**City of Kitchener**  
**OPA & ZBA Comment Form**

**Project Address:** 9-27 Turner Ave, Kitchener

**Application Type:** Official Plan Amendment & Zoning Bylaw Amendment

**Application Type: Zoning By-law Amendment Application ZBA24/018/T/TS**

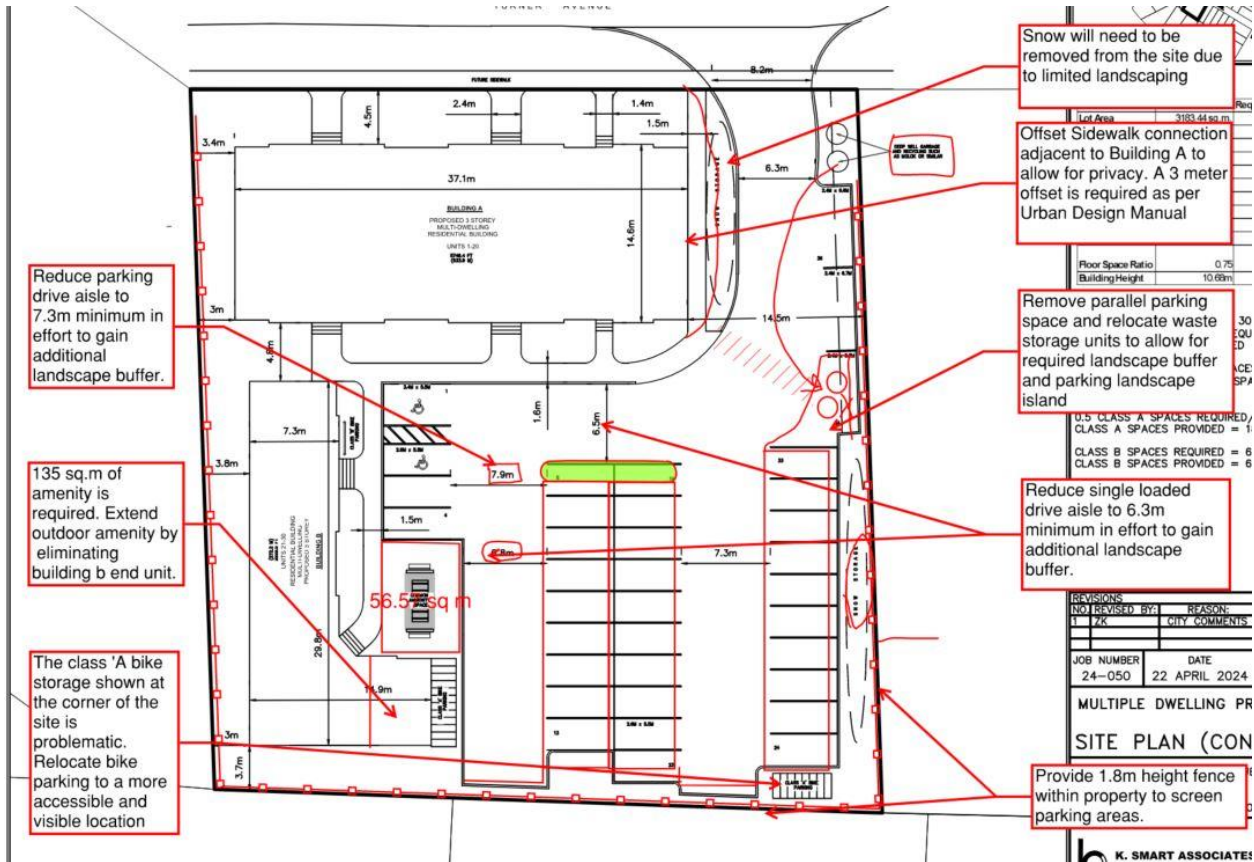
- 135 sq. m of amenity is required. Extend outdoor amenity by eliminating building B end unit.
- The class 'A' bike storage shown at the corner of the site is problematic. Relocate bike parking to a more accessible and visible location.
- Reduce double loaded parking drive aisle to 7.3m minimum in effort to gain additional landscape buffer.
- Reduce single loaded drive aisle to 6.3m minimum in effort to gain additional landscape buffer.
- Remove parallel parking space and relocate waste storage units to allow for required landscape buffer and parking landscape island. See mark-up below.

- Offset sidewalk connection adjacent to Building A. A 3-meter offset is required as per Urban Design Manual
- Snow will need to be removed from the site due to limited landscaping. Make note on the plan.
- Provide 1.8m height fence within property to screen parking areas.
